ADDENDUM 01

DATE 02.04.23
 PROJECT NO. 2154
 PROJECT WEST FIELD SR. SEMINARY
 FROM STUDIO 333 ARCHITECTS

This Addendum forms a part of the Contract Documents and modifies the original Bidding Documents dated 01.25.23, as noted below. Acknowledge receipt of this Addendum in the space provided on the Bid Form. Failure to do so may subject the Bidder to disqualification.
This Addendum consists of 2 pages and the attached Drawing Sheets SD1.1, CE1.1, CE2.1, CE3.1, CE4.1, CE5.2, L201, A1.3, A5.1, A5.11, EP101, EP102, EE501, ES101,

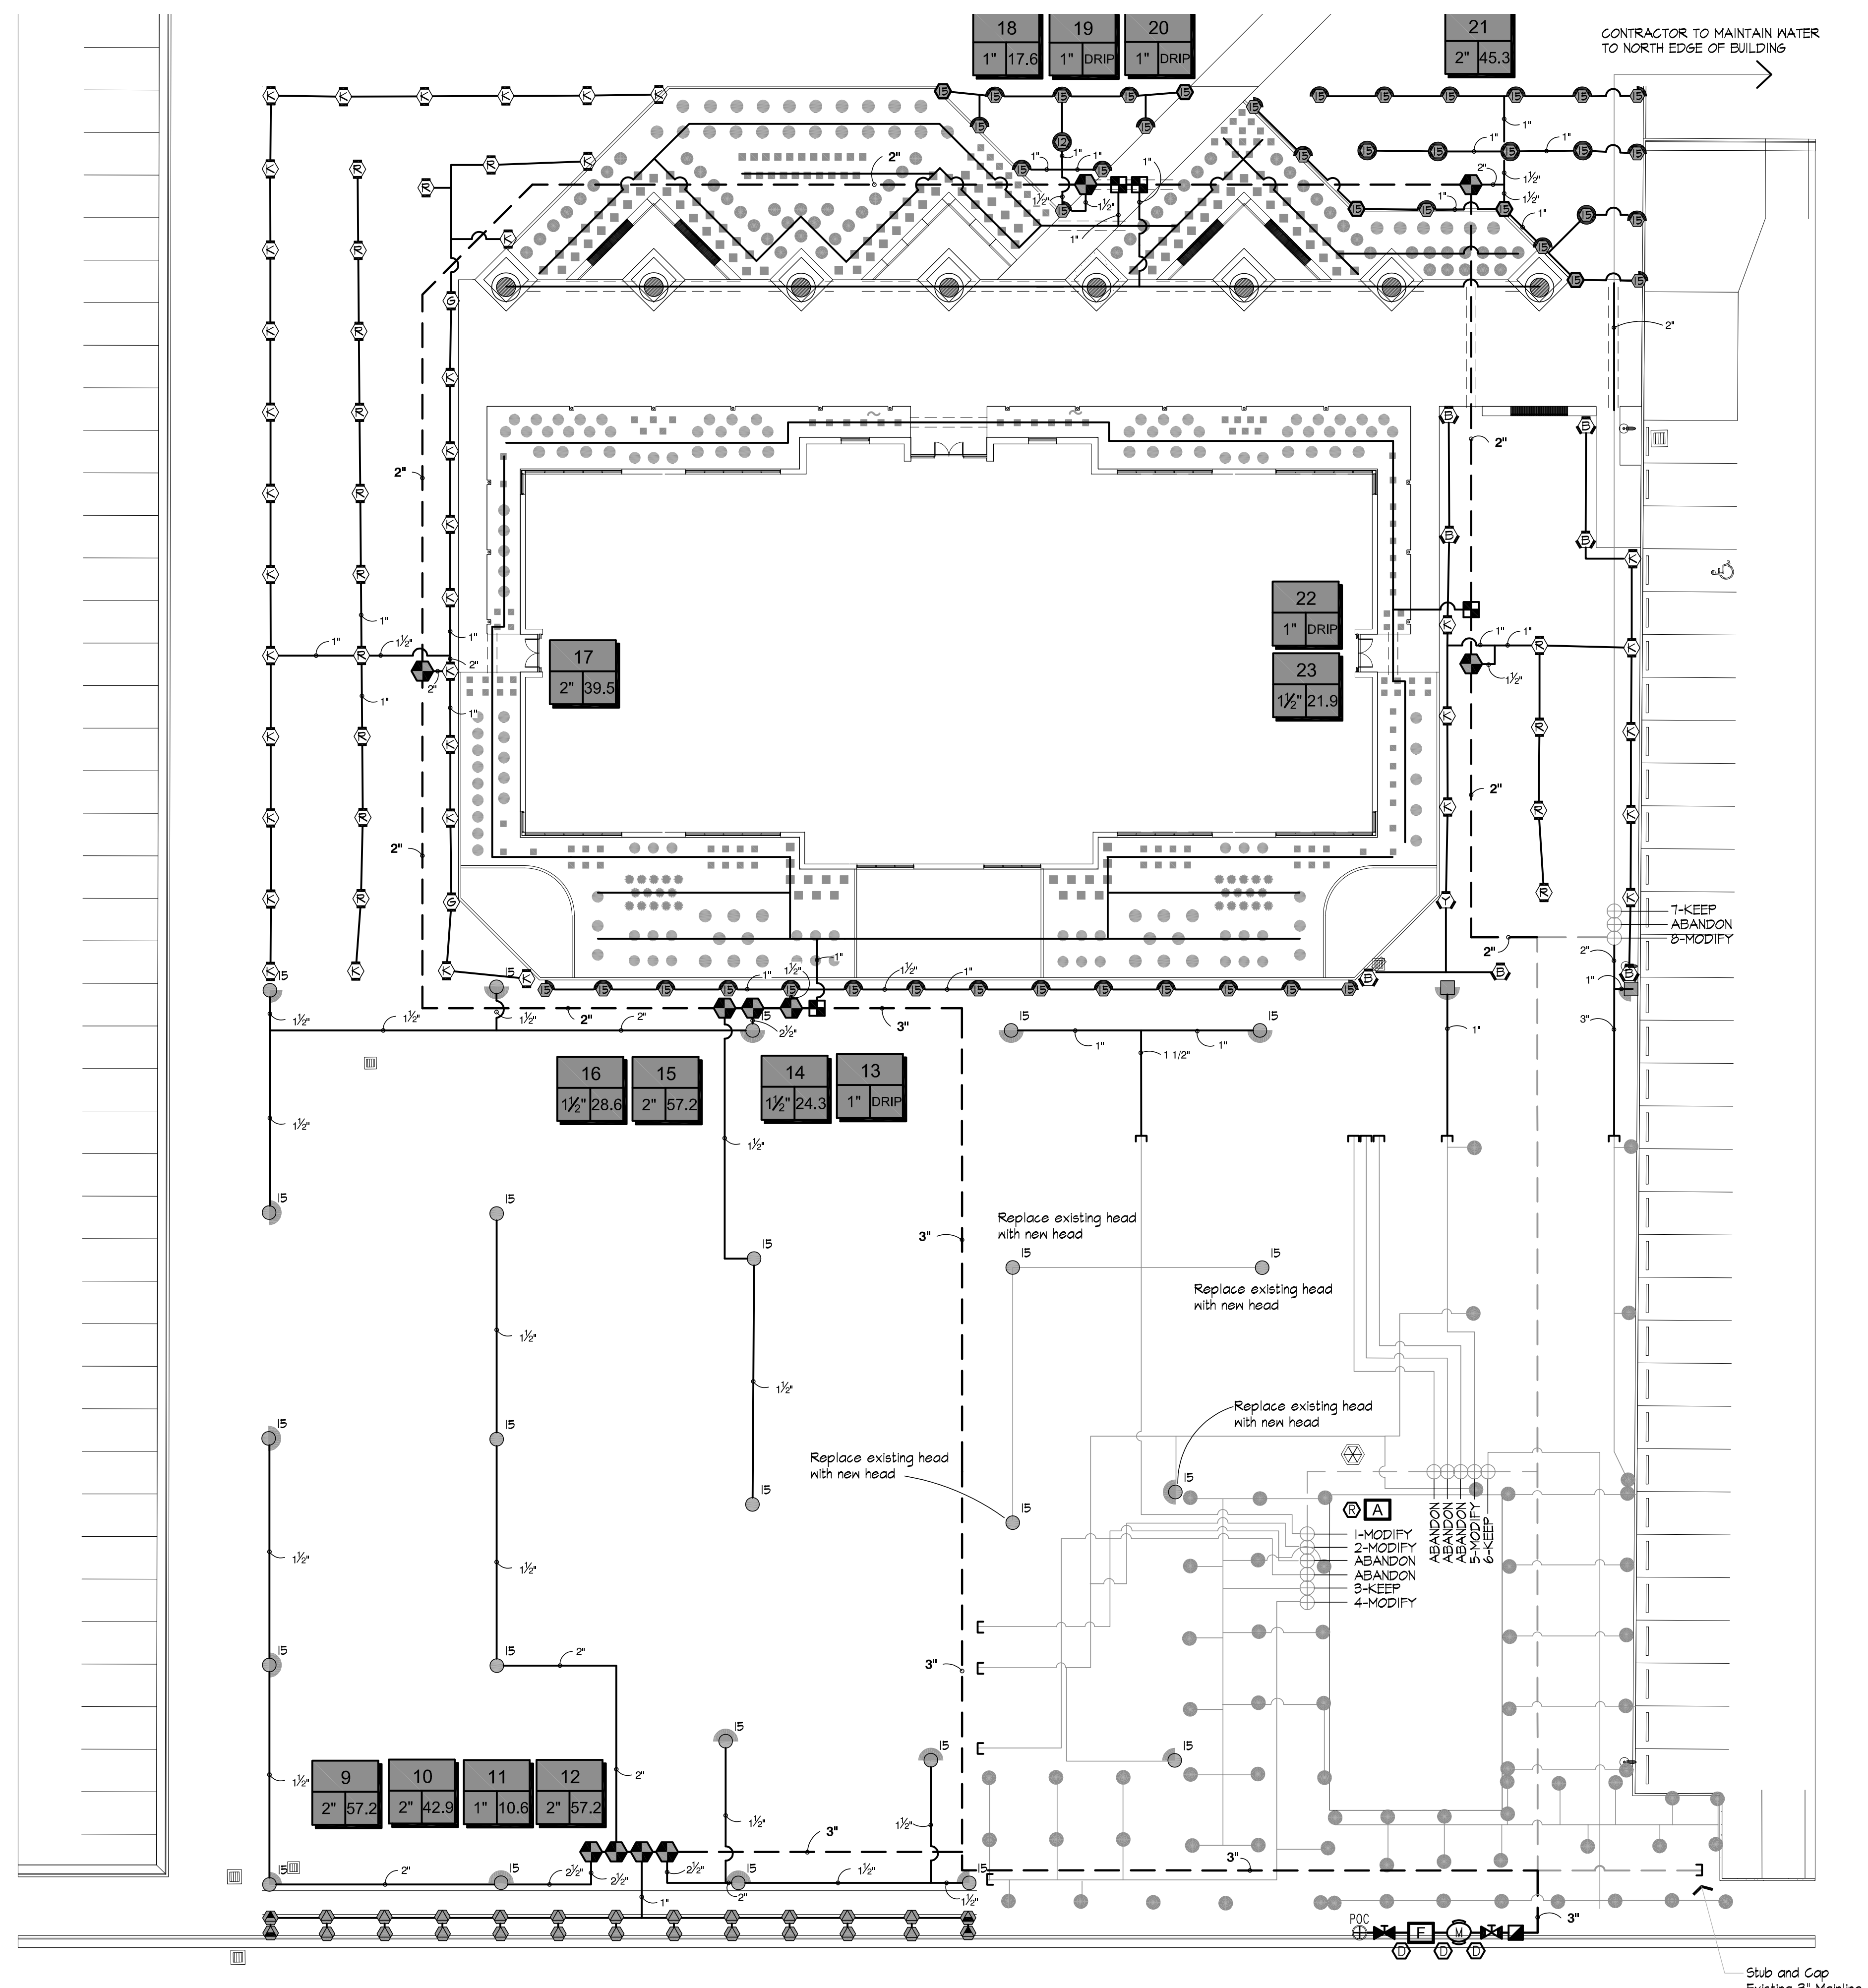
- 7. Sheets L201 - IRRIGATION PLAN and ES101 - ELECTRICAL SITE PLAN:
 - a. Relocate the existing Weather Trak Sprinkler Controller from the existing pavilion structure to the back of the seminary building near the electrical equipment.

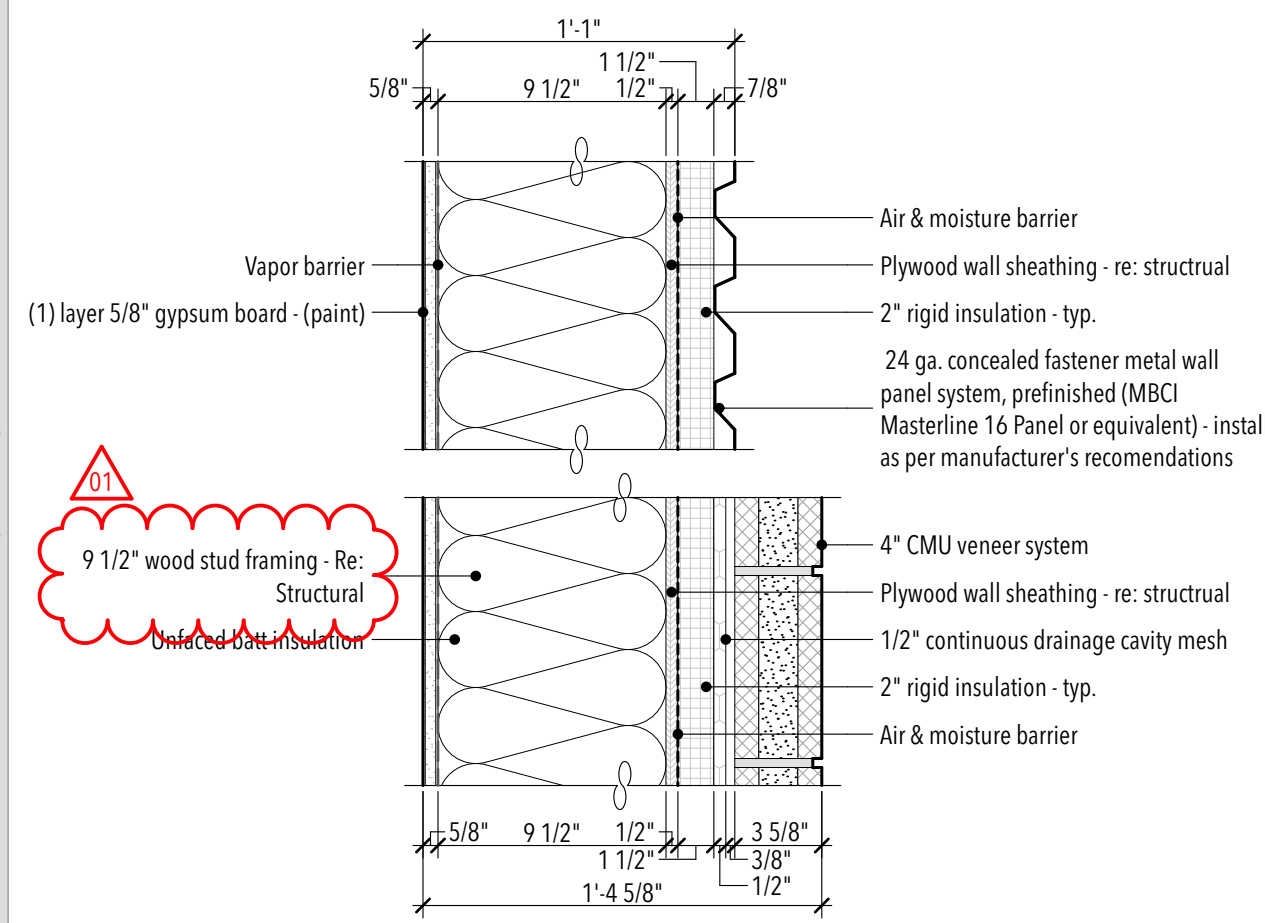
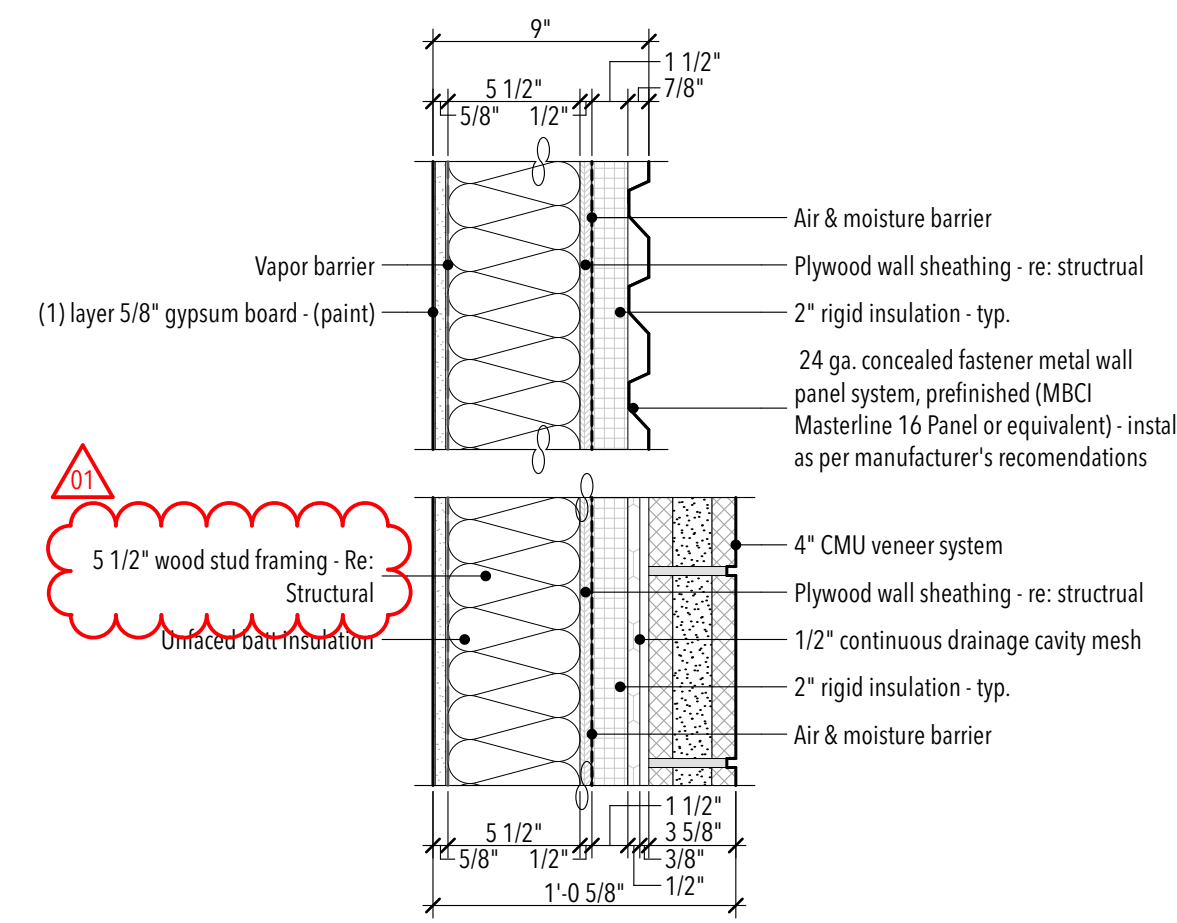
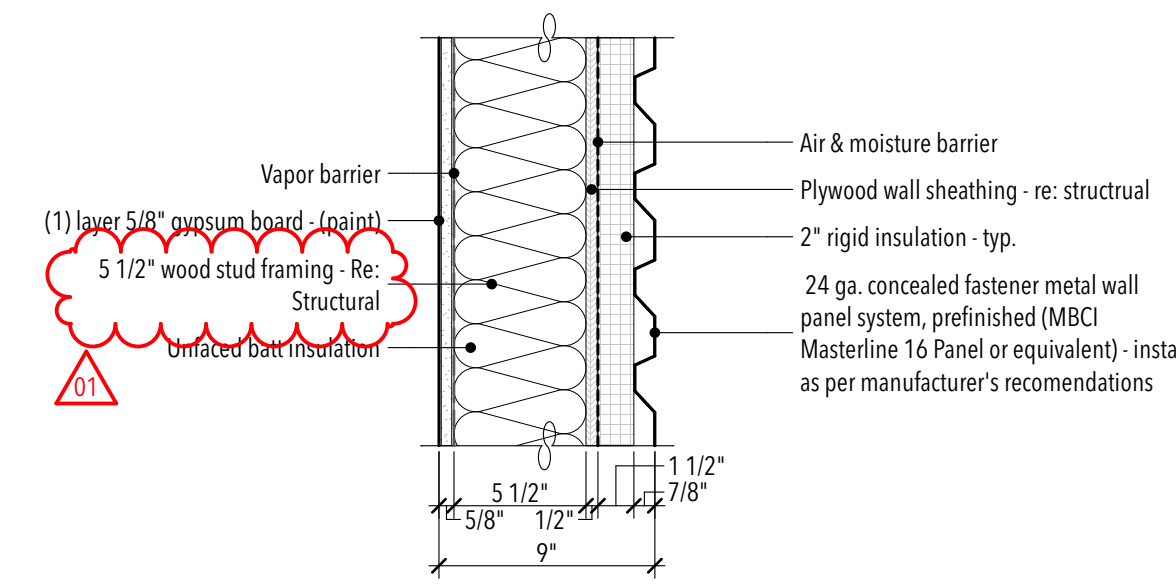
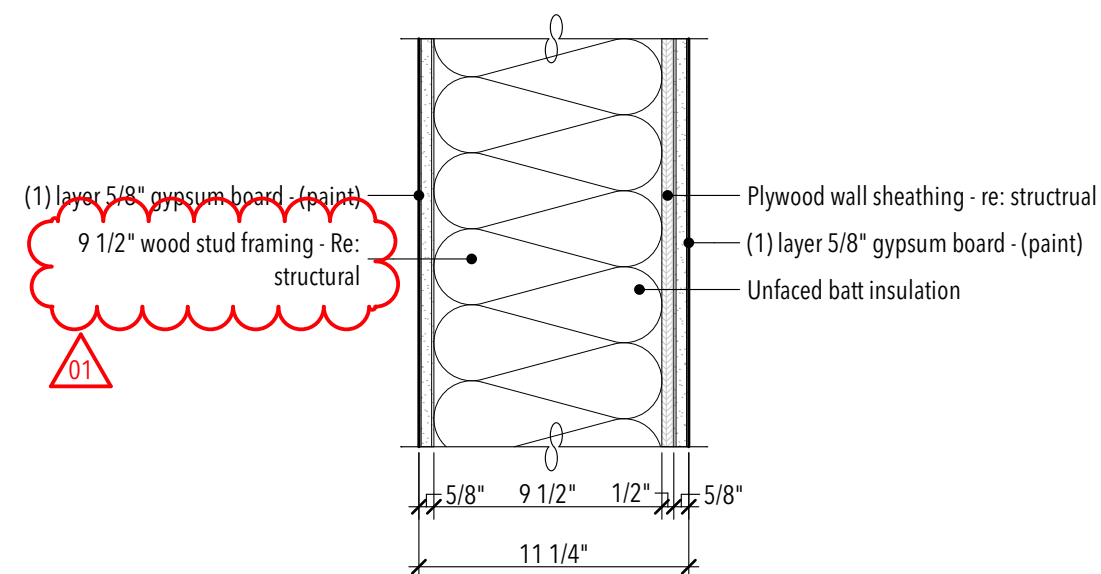
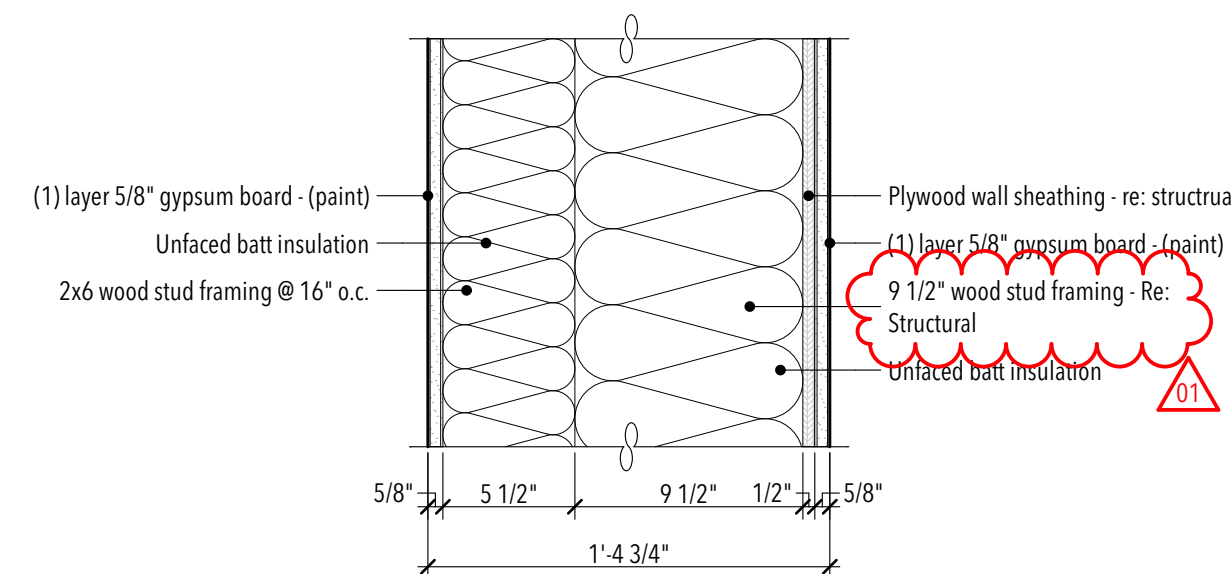
- 8. Sheet A1.3 - PARTITION TYPE DETAILS:
 - a. Added notes to reference structural drawings for stud framing requirements at shear wall and bearing wall location at Partition types 01, 02, 03, 09 and 10. As a clarification, all shear walls and bearing walls shall be framed with LVL studs.

1ST LEVEL ENLARGED PLAN

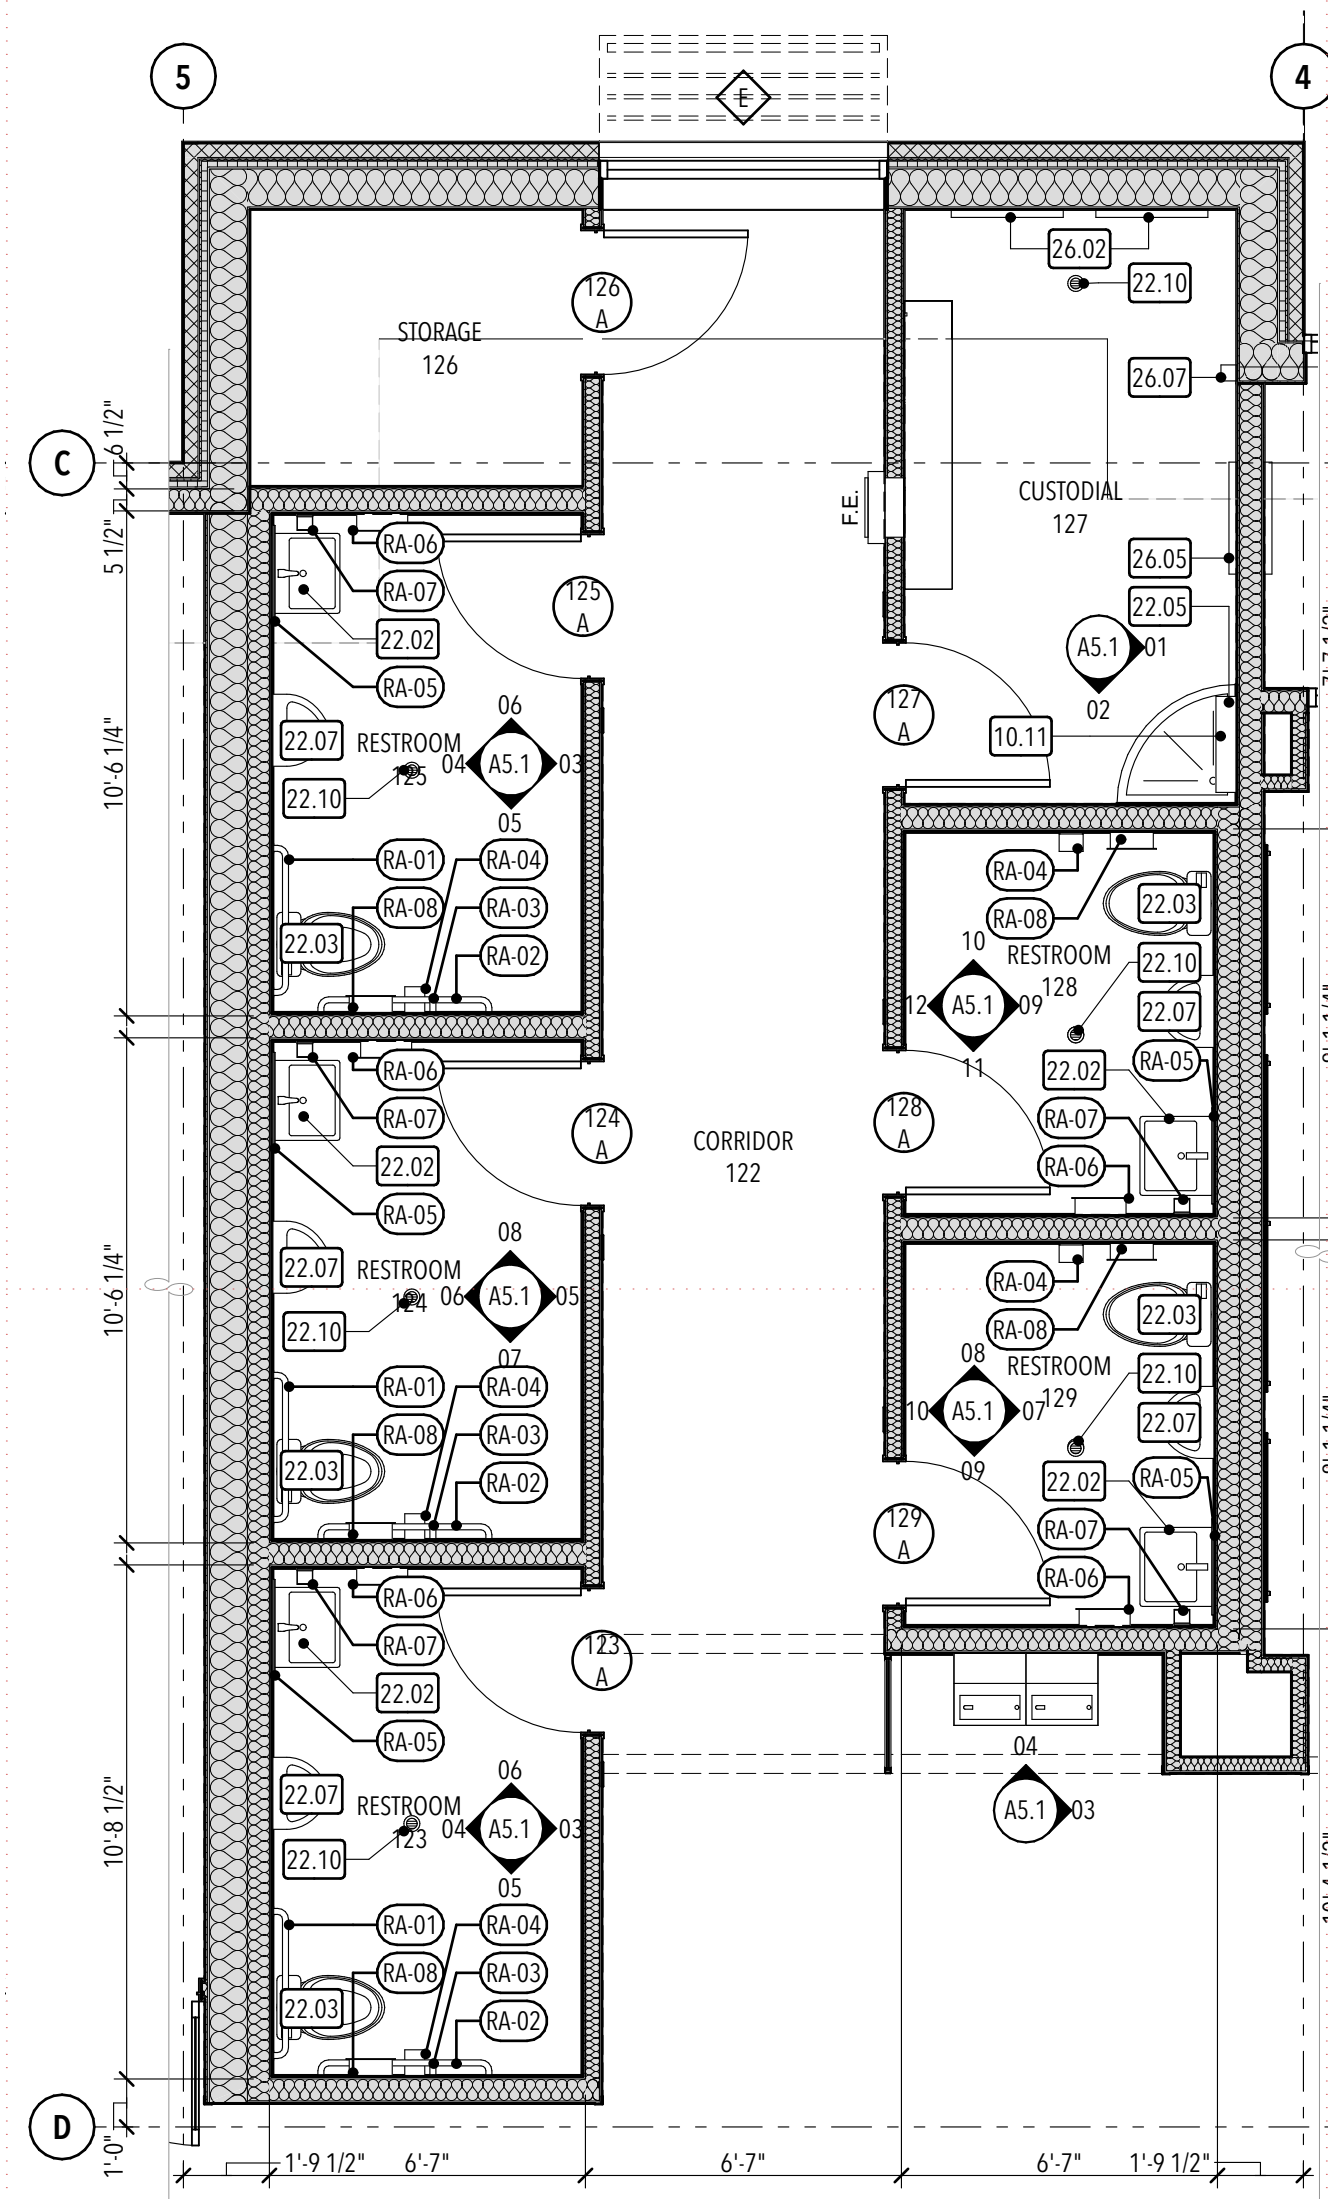
- 9. Sheet A5.1 - 1ST LEVEL ENLARGED PLAN:
 - a. Change restroom accessories RA-5, RA08 and RA-09 to be Contractor furnished and installed.
- 10. Sheet A5.11 - INTERIOR ELEVATIONS:
